Addendum-2

Electricity Transmission Code (ver2, rev. 2 dated 30 June 2020) - Update to include Large Renewables and HVDC Requirements

Issue Date: 31 May 2021

Approved by Department of Energy

Figure xxx1 Expected withstand durations and expected real power capacity during system frequency deviations.

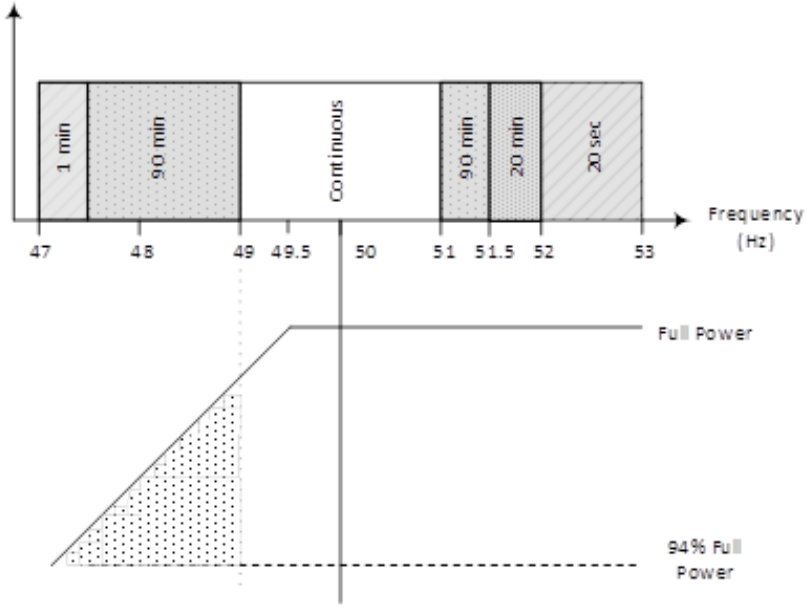
S.N	Code Reference Chapter/Section/Page	Statement per the Code (ETC ver.2 Rev.2 dated 30 June 2020)	Proposed Amendment/New Statement
			<p>49 - 51Hz Continuous operation is required. Any decrease of output power occurring in the frequency range of 47 to 49.5 Hz should not be more than pro-rata with System Frequency.</p> <p>51- 51.5 Hz Operation for a period of at least 90 continuous minutes is required each time the System Frequency is above 51 Hz. Decrease of output power is not permitted.</p> <p>51.5 – 52 Hz Operation for a period of at least 20 continuous minutes is required each time the System Frequency is above 51.5Hz. Decrease of output power is not permitted.</p> <p>52 – 53 Hz Operation for a period of at least 20 continuous seconds is required each time the System Frequency is above 52Hz. Decrease of output power is not permitted.</p> <p>The proposed requirements for HVDC are depicted in the above Table xxx1 and Figure xxx1 below.</p>

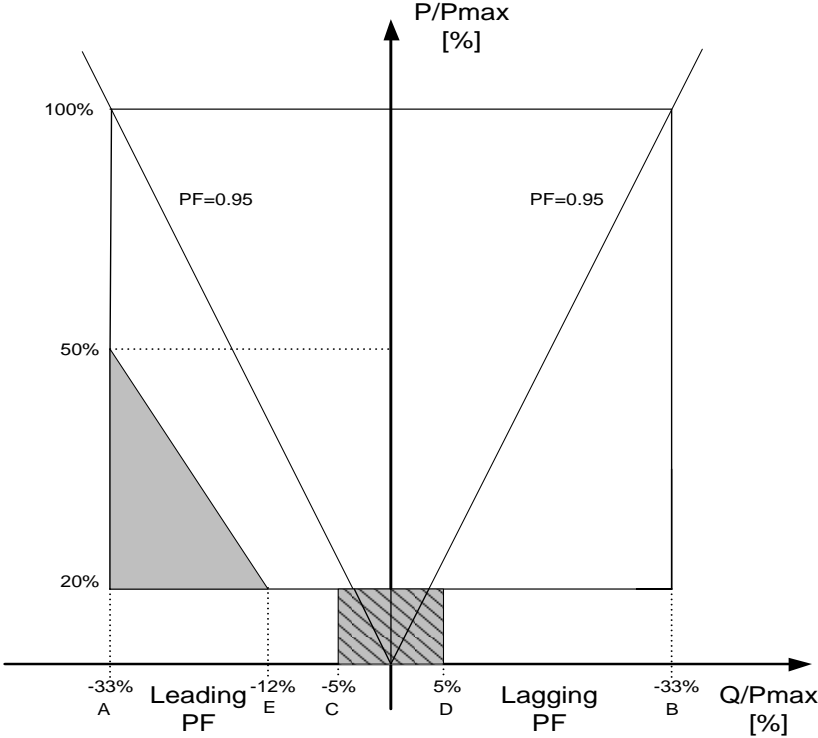
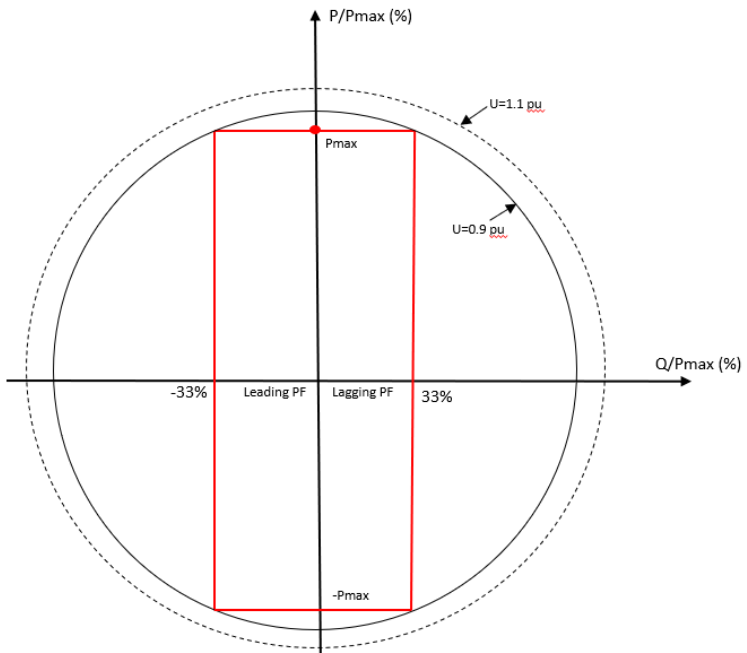
S.N	Code Reference Chapter/Section/Page	Statement per the Code (ETC ver.2 Rev.2 dated 30 June 2020)	Proposed Amendment/New Statement
		<p>All Non-Synchronous Generating Units and Power Farm Generating Units must be capable of supplying Rated MW output between the limits 0.95 Power Factor lagging and 0.95 Power Factor leading at the Transmission Entry Point (or User System Entry Point, if Embedded) subject to the paragraphs below and Figure 6.1.</p> <p>With all Plant in service, the Reactive Power limits defined at Rated MW at lagging Power Factor will apply at all Active Power output levels above 20% of the Rated MW as defined in Figure 6.1. With all Plant in service, the Reactive Power limits defined at Rated MW at leading Power Factor will apply at all Active Power output levels above 50% of the Rated MW output as defined in Figure 6.1. With all Plant in service, the Reactive Power limits will reduce linearly below 50% Active Power output as shown in Figure 6.1 unless the requirement to maintain the Reactive Power limits defined at Rated MW at leading Power Factor down to 20% Active Power output is specified in the Bilateral Agreement. These Reactive Power limits will be reduced pro rata to the amount of Plant in service.</p> <p>For the avoidance of doubt, all Non-Synchronous Generating Units and Power Farm Generating Units must be capable of providing, as a minimum, Reactive Power as defined in the “V” characteristic of Figure 6.1 bordered by the 0.95 leading and lagging Power Factor lines. Where the Non-Synchronous Generating Units and Power Farm Generating Units have an inherent capability to provide Reactive Power in accordance with the quadrilateral characteristic or TRANSCO has a system requirement for the Non-Synchronous Generating Units and Power Farm Generating Units to provide Reactive Power in accordance with the quadrilateral characteristic, TRANSCO will notify the User of this requirement and it shall be formalised in the Bilateral Agreement.</p>	<ul style="list-style-type: none"> The Power Park Module, HVDC systems as well as Battery Storage must allow the reactive power utilisation to the greatest possible extent, but at least as per P-Q capability diagram presented in Figure xxx2 where the Reactive Power capability at the Transmission Entry Point shall not be less than the $\pm 33\%$ of the rated power (that corresponds to the power factor of 0.95 leading/lagging) at: <ul style="list-style-type: none"> Any level of Active Power output, including zero Active Power level Any voltage at the connection point within the limits 0.9-1.1 p.u <div data-bbox="1855 808 2611 1249" data-label="Figure"> </div> <p>Figure xxx2: P-Q capability of the Non-synchronous Power Park Module and uni-directional HVDC</p> <ul style="list-style-type: none"> Point A is equivalent to leading 0.95 Power Factor at Rated MW output Point B is equivalent to lagging 0.95 Power Factor at rated MW output Point C represents theoretical inverter limit (leading) at zero MW output Point D represents theoretical inverter limit (lagging) at zero MW output <p>(capability between A and C and between B and D may be required in separate bilateral agreement depend on the internal constraints, but it does not belong to standard capabilities)</p> <ul style="list-style-type: none"> The Battery Storage must allow the reactive power utilisation to the greatest possible extent, but at least as per P-Q capability diagram presented in Figure xxx3. This maybe applicable to HVDC systems connecting two systems and required to be capable of bi-directional power flow.

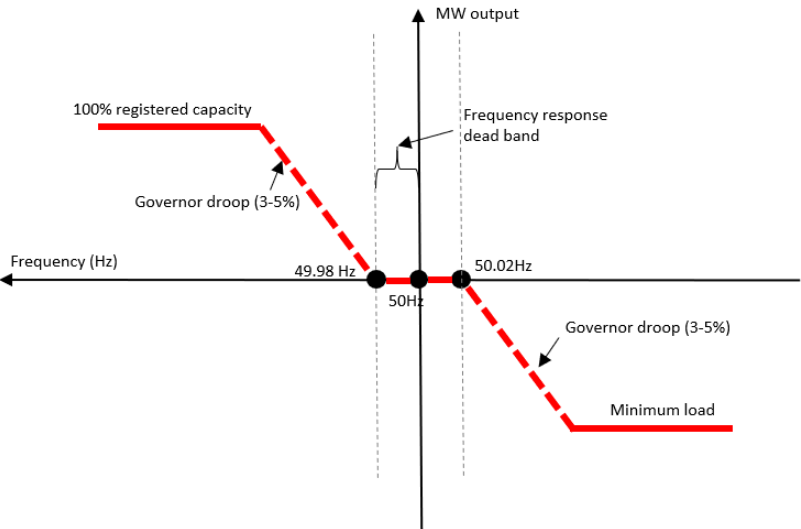
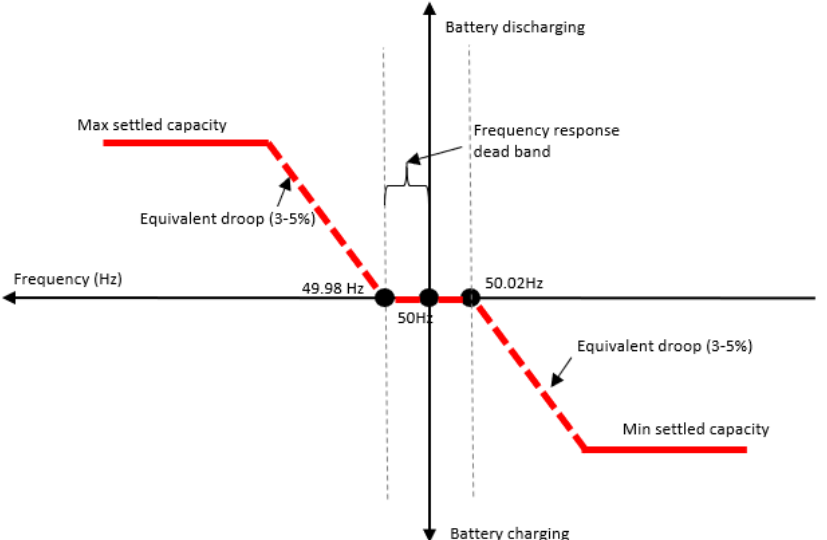
S.N	Code Reference Chapter/Section/Page	Statement per the Code (ETC ver.2 Rev.2 dated 30 June 2020)	Proposed Amendment/New Statement
		<p>The Unit Controller shall be sufficiently damped for both isolated and interconnected operation modes. Under all operation conditions, the damping coefficient of the Unit Controller shall be above 0.25 for speed droop settings above 3% for gas turbines and 5% for steam turbines. In the case of a Power Farm the speed droop should be equivalent of a fixed setting between 3% and 5% applied to each WTGU or PVGU in service.</p> <p>In the case of all Generating Units the Frequency Control device (or speed governor) deadband should be no greater than 0.04Hz (for the avoidance of doubt, ± 0.02Hz). Under all system operation conditions, the Synchronous Generating Unit speed shall not exceed 106%.</p> <p>For generator oscillations with frequencies below 2 Hz, the Unit Load Controller shall have no negative effect on generator oscillation damping.</p> <p>The Normalized Primary Response Characteristic as defined by the Primary Response Performance Index shall be maintained under all operation conditions. Consequently, in the event that a Generating Unit becomes isolated from the System but is still supplying Demand the Generating Unit must be able to provide Primary Control according to the Primary Response Performance Index.</p> <p>All steam turbine Generating Units must be fitted with a Unit Controller which is designed and operated to the requirements of IEC 45.</p> <p>All Gas Turbine Units must be fitted with a Unit Controller capable of a power related speed droop characteristic of between 3% and 5%.</p>	<p>For generator oscillations with frequencies below 2 Hz, the Unit Load Controller shall have no negative effect on generator oscillation damping.</p> <p>The Normalized Primary Response Characteristic as defined by the Primary Response Performance Index shall be maintained under all operation conditions. Consequently, in the event that a Generating Unit becomes isolated from the System but is still supplying Demand the Generating Unit must be able to provide Primary Control according to the Primary Response Performance Index.</p> <p>All steam turbine Generating Units must be fitted with a Unit Controller which is designed and operated to the requirements of IEC 45.</p> <p>All Gas Turbine Units must be fitted with a Unit Controller capable of a power related speed droop characteristic of between 3% and 5%.</p> <p>Non-synchronous Generating Units</p> <p>A Unit Controller of each Power Park Module or HVDC must be capable of providing frequency response under the following modes:</p> <ul style="list-style-type: none"> - Normal Frequency Sensitive Mode - Limited Frequency Sensitive Mode - Over frequency - Limited Frequency Sensitive Mode - Under frequency <p>The Unit Controller or equivalent control device(s) may be on the Power Park Module or on each individual AC/DC converter. Power Park Module or HVDC will only be expected to deliver response as per their Power Purchase Agreement.</p> <p>A Unit Controller of each Battery Storage must be capable of providing frequency response under the Normal Frequency Sensitive Mode.</p> <p>The following shall apply for Power Park Module, HVDC (see Figure xxx4) and/or Battery Storage (see Figure xxx5) operating in Normal Frequency Sensitive Mode:</p> <ul style="list-style-type: none"> - A Frequency Deadband of no greater than +/- 20mHz may be applied. The design, implementation and operation of the Frequency Deadband shall be agreed with the system operator prior to the Commissioning. - The Active Power Frequency Response shall be capable of having a Governor Droop between 3% and 5%. - In response to low frequency events, Power Park Module, HVDC and/or Battery Storage shall be capable of providing a power increase up to Available Active Power. Stable operation in response to low frequency events shall be ensured.

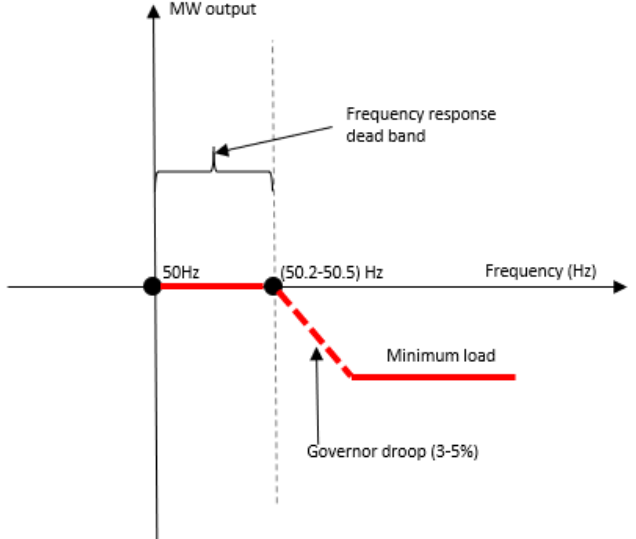
S.N	Code Reference Chapter/Section/Page	Statement per the Code (ETC ver.2 Rev.2 dated 30 June 2020)	Proposed Amendment/New Statement
			 <p>Figure xxx4: Normal Frequency Sensitive Mode</p>  <p>Figure xxx5: Normal Frequency Sensitive Mode for Battery Storage</p> <p>The following shall apply for Power Park Module or HVDC operating in Limited Frequency Sensitive Mode – Over Frequency (see Figure xxx6):</p> <ul style="list-style-type: none"> - Power Park Module or HVDC shall be capable of providing Active Power Frequency Response when the Transmission System Frequency rises to or above threshold which should be set in range 50.2 – 50.5 Hz.

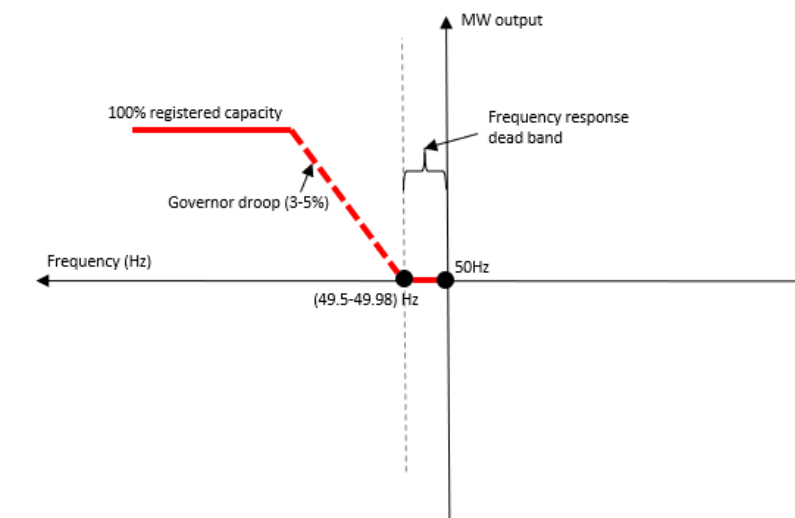
S.N	Code Reference Chapter/Section/Page	Statement per the Code (ETC ver.2 Rev.2 dated 30 June 2020)	Proposed Amendment/New Statement
			<ul style="list-style-type: none"> - The Active Power Frequency Response shall be capable of having a Governor Droop between 3% and 5%. - Power Park Module or HVDC shall be capable of providing a power decrease down to Minimum Load. Stable operation shall be ensured. - Power Park Module or HVDC shall be capable of continuous stable operation when MW Output is reduced to Minimum Load. This response will prevail over any other Active Power control mode. <div style="text-align: center;">  <p>The graph plots MW output on the vertical axis against Frequency (Hz) on the horizontal axis. A horizontal line at 50Hz represents the normal operating point. A vertical dashed line at 50.2 Hz marks the start of the frequency response dead band. Between 50Hz and 50.2 Hz, the MW output remains constant. From 50.2 Hz to 50.5 Hz, the MW output decreases linearly, labeled as 'Governor droop (3-5%)'. Below 50.5 Hz, the MW output remains constant at a level labeled 'Minimum load'.</p> </div> <p style="text-align: center;">Figure xxx6: Limited Frequency Sensitive Mode – Over Frequency</p> <p>The following shall apply for Power Park Module or HVDC operating in Limited Frequency Sensitive Mode – Under Frequency (see Figure xxx7):</p> <ul style="list-style-type: none"> - The mode should be activated under curtailed conditions (solar and/or wind). - Power Park Module or HVDC shall be capable of providing Active Power Frequency Response when the System Frequency falls to or below the threshold which should be set in range 49.5 – 49.98 Hz. - A Frequency Deadband of no greater than +/- 20mHz may be applied. The design, implementation and operation of the Frequency Deadband shall be agreed with the TSO prior to the Commissioning. - The Active Power Frequency Response shall be capable of having a Governor Droop between 3% and 5%. - Power Park Module or HVDC shall be capable of providing a power increase up to Available Active Power. Stable operation shall be ensured.

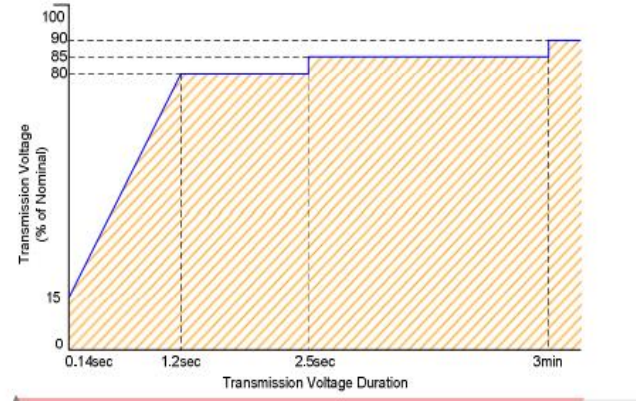
S.N	Code Reference Chapter/Section/Page	Statement per the Code (ETC ver.2 Rev.2 dated 30 June 2020)	Proposed Amendment/New Statement
		<p>Agreement. Operation of such control facilities shall be in accordance with the Scheduling and Despatch Code.</p>	<div data-bbox="1863 464 2614 957" data-label="Figure"> </div> <p style="text-align: center;">Figure xxx 8– Voltage control slope</p> <ul style="list-style-type: none"> - reactive power control mode when the Power Park Module, HVDC or Battery Storage shall be capable of receiving the Reactive Power setpoint anywhere in the reactive power range specified in clause 6.3.1 of the ETC (chapter 3), with setting steps no greater than 5 Mvar or 5 % (whichever is smaller) of maximum Reactive Power, controlling the Reactive Power at the Transmission Entry Point to an accuracy within ± 5 Mvar or ± 5 % (whichever is smaller) of the maximum Reactive Power. - power factor control mode when the Power Park Module, HVDC or Battery Storage shall be capable of receiving the Power Factor setpoint anywhere inside the mandatory or agreed Reactive Power capability region with setting steps no greater than 0.01 pu. The Power Factor shall be maintained within a tolerance of ± 0.5 %. The tolerance will be measured with reference to the maximum Reactive Power at the Connection Point. <p>TRANSCO (i.e. System Operator) shall specify which of the above three control modes and associated setpoints is to apply. Any change of the control mode and the set point shall be implemented by the Power Park Module, HVDC or Battery Storage upon receipt of the appropriate signal from the TRANSCO.</p> <p>The specific requirements for automatic excitation control facilities, including Power System Stabilizers (Power Oscillation Damping controls), where these are necessary for system reasons, shall be specified in the Power and Water Purchase Agreement or the Connection and Interface Agreement. Operation of such control facilities shall be in accordance with the Scheduling and Despatch Code.</p>

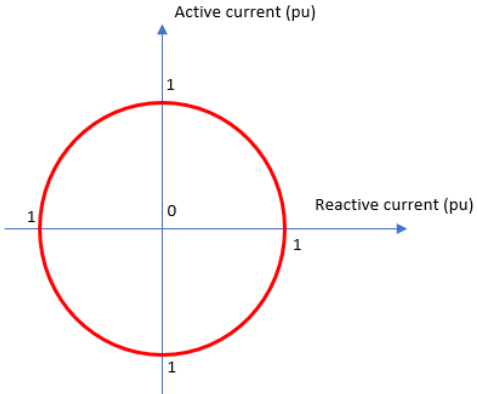
S.N	Code Reference Chapter/Section/Page	Statement per the Code (ETC ver.2 Rev.2 dated 30 June 2020)	Proposed Amendment/New Statement
43	Chapter-3, Connection Conditions, Section-6 (Technical, Design and Operational Criteria) Subsection 6.3 (Generating Unit Requirements) Clause 6.3.8 Dynamic Reactive Current Control Pages 90-91	Not defined	<p>Dynamic Reactive Current Control</p> <p>In addition to the requirements from 6.3.2.2.(ETC) and 6.3.7.(ETC) and for any balanced fault which results in the voltage falling below the voltage levels specified in CC.6.1.2 at the point of connection, each Non-synchronous Generating Unit (including Battery Storage that connects to Transmission System) shall, as a minimum, be required to inject a reactive current above the heavy red line shown in Figure xxx10:</p> <p>Figure xxx10 – Dynamic reactive current for Generating Unit (including Battery Storage)</p> <p>In addition, each non-synchronous Generating Unit (including Battery Storage that connects to Transmission System) shall be required to inject at least 2/3 of nominal reactive current, decreased by pre-fault level, in 60ms after the voltage dip, with 20ms of control response time.</p> <p>HVDC system shall be capable of injecting reactive current at its connection point if specified by TRANSCO. The amount of reactive current injection shall be specified by the TRANSCO.</p> <p>The fault conditions shall be identified, for instance, through the detection of a low voltage at the point of connection. The specific short circuit contribution shall be agreed as part of the connection process. TRANSCO may request the contribution of positive, negative and zero sequence currents depending on the requirements of fault detection near the Connection point.</p> <p>When a specific HVDC system is required to provide short circuit current contribution, the following parameters shall be defined as part of the connection process.</p> <ul style="list-style-type: none"> • Voltage threshold for activation (e.g. 85 % - 90% of rated nominal voltage). • The characteristics (magnitude in relation to voltage dip) of the injected current in time domain <ul style="list-style-type: none"> ○ As a minimum, the reactive current injection shall be in proportion to the available voltage at the connection point.
